ADDENDUM NO. 1

DATE: 1/17/2023

REVISIONS TO:
Request for Bids Specification No. PW22-0372N

COMMERCE STREET RAILING REPAIR – REBID

BREAKAWAY POST BRACKET ASSEMBLY
NTS

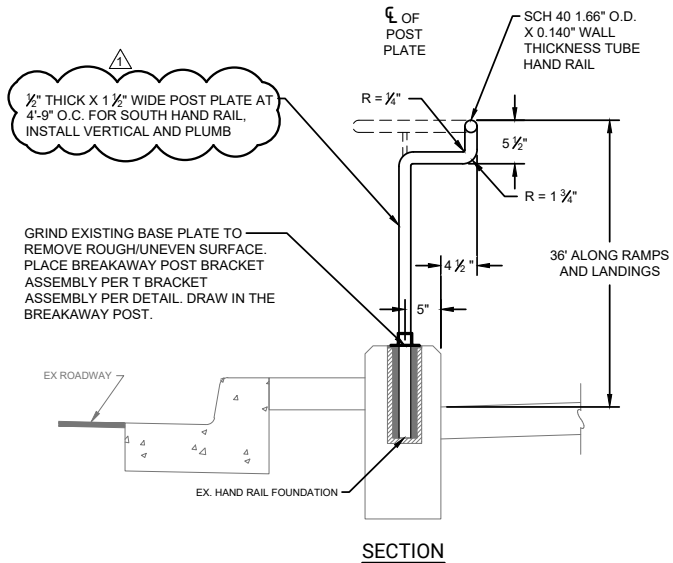
For the proposed Breakaway Post Brackets shown on sheet 60000052980:
The post dimensions should say ½” thick x 1 ½” wide post.

Here is a recommended Breakaway Post Bracket Manufacturer and Model Number:

Model No.	Model Name	Manufacturer
32.15.01	Break-Safe Model AP	Transpo Industries, Inc.

Amend detail sheet 60000052980 with the attached detail sheet 60000052980
(Addendum #1 dated 1/17/2023).
